EIRS Bulletin

No. 98-02

Date: 22 April 1998

ENG FORMS 3078

20-180 DDC SERIES 40 DUAL WALLED
SUB-BASE FUEL TANKS (DIESEL ONLY)

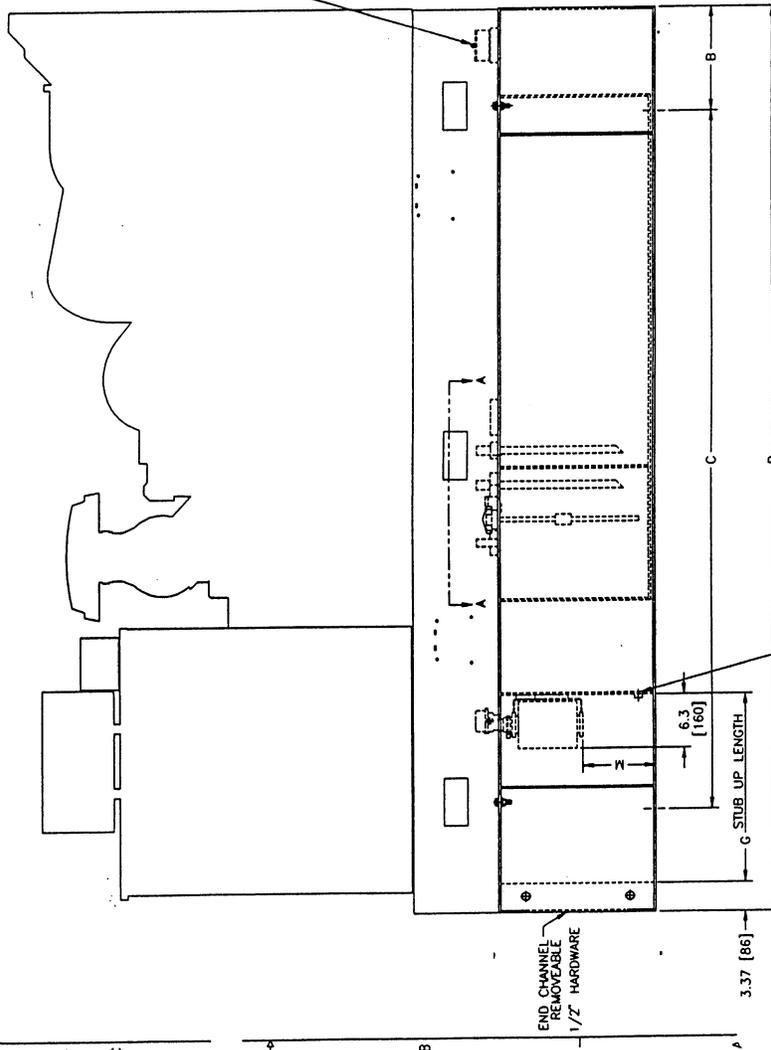
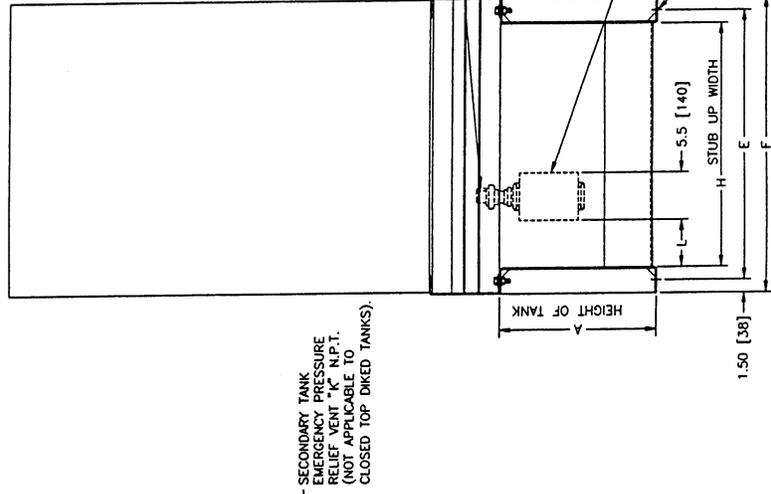
No option for skid mounted base fuel tank. Skid mounted base tanks are often more desirable and economical than a separate (above ground or underground) fuel tank; and, are especially suited for self contained units.

See marked up CEGS-16263 excerpt (enclosure 1). Also, see typical catalog cut (enclosure 2).

Forwarded for evaluation. The definitions in CEGS 16263 for "self-supporting" and "integral" day tank" are ambiguous, as subject proposal illustrates. Recommend that the USACE Fire Protection Engineer be consulted as to the need for base-mounted tanks to be double-walled.
OFFICE SYMBOL: CENWD-ET
NAME AND TITLE (Print or Type): DAVID N KELLER, P.E. Chief, Engineering Division
DATE: NOV 12 1997
SIGNATURE: [Signature]

COMMENTS OR ACTION BY COMMANDER, USACE
Concur except reference to "doublewall tank construction" will be deleted.
OFFICE SYMBOL: CEMP-E
NAME AND TITLE (Print or Type): KISUK CHEUNG, P.E. C, ENGR AND CONST DIV., DM/P
DATE: 4/17/98
SIGNATURE: for Mohan [Signature]
